MEETING WITH R.E. GINNA NUCLEAR POWER PLANT, LLC (GINNA LLC), REGARDING EXTENDED POWER UPRATE AMENDMENT APPLICATION (TAC NO. MC7382)

Thursday, November 17, 2005 LOCATION: U.S. Nuclear Regulatory Commission One White Flint North Rockville, Maryland

POST-LOCA LONG-TERM COOLING RAIS

DRAFT RESPONSE PLAN

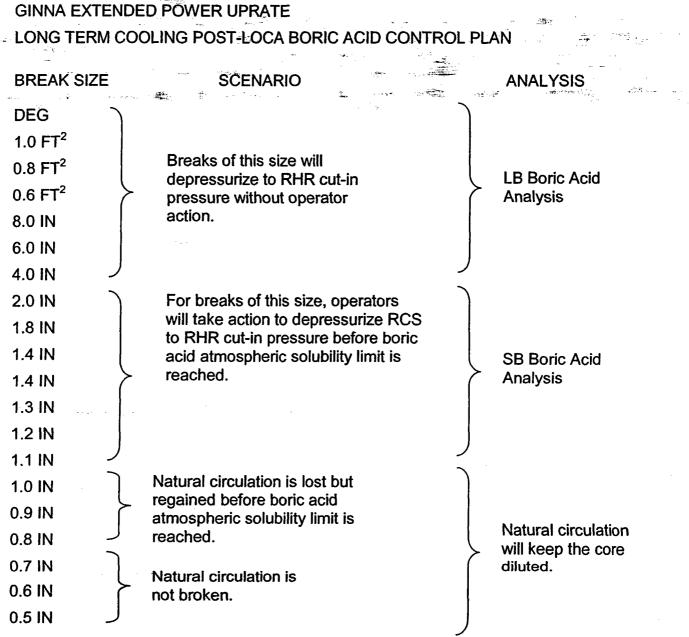
- 2. Small breaks were not addressed. The boric acid concentration for the limiting SBLOCA needs to be evaluated. Provide a summary of the results to show that the boric acid concentration is not sufficient to cause precipitation should the operators inadvertently depressurize the reactor coolant system (RCS) in a rapid manner.

- A SBLOCA boric acid analysis is being performed for a break size such that system depressurization will occur without operator actions. A "system depressurization time" will be determined using the boric acid solubility limit at atmospheric conditions. Breaks smaller than this will require operator action to begin cooldown (assumed to be within 1 hour of the LOCA event). Depressurization to RHR cut-in pressure will occur within the "system depressurization time", assuring boric acid precipitation cannot occur. For very small breaks (approximately 1.0 inches) the RCS will can be refilled sufficiently such that natural circulation will be restored within the system depressurization time. (see next RAI response).

Inadvertent RCS depressurization will not cause boric acid precipitation when it occurs before the "system depressurization time" since the boric acid atmospheric solubility limit will not be exceeded. After the "system depressurization time" the UPI flow or natural circulation flow will be flushing the core.
